Proposal for amendments to the 04 series of UN Regulation No.41 (Noise Emissions of motorcycles)

The text reproduced below was prepared by the expert from IMMA to clarify definitions provided in Regulation No. 41. The proposed amendments to the current Regulation are incorporated into the consolidated text and marked in bold for new or strikethrough for deleted characters.

2.2.3 – Examples of multiple exhaust versions which may be covered by one approval.

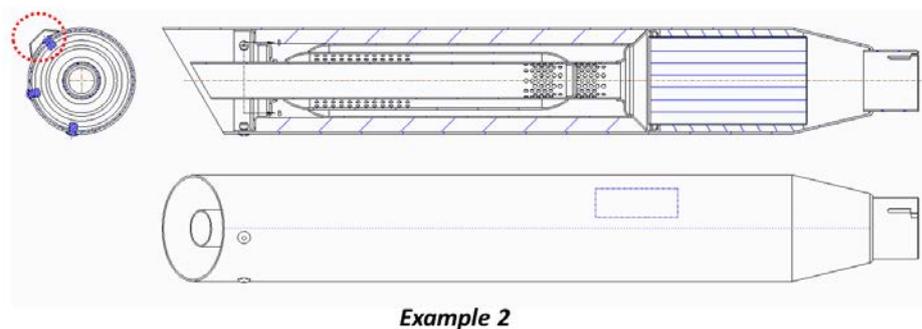
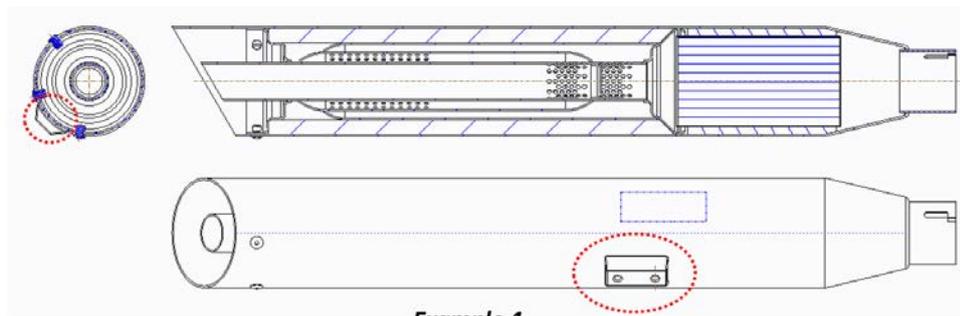
- 2.2.2. Transmission system, in particular the number and ratios of the gears;
- 2.2.3. Number, type, arrangement **and internal geometry** of exhaust or silencing systems, **as defined in 2.3 and 2.4.**

A. Exhaust versions with fundamentally identical internal geometries (same noise emission, different mounting brackets)

B. Exhaust versions with different shell materials or cosmetic finish (e.g. black painted versus chrome)
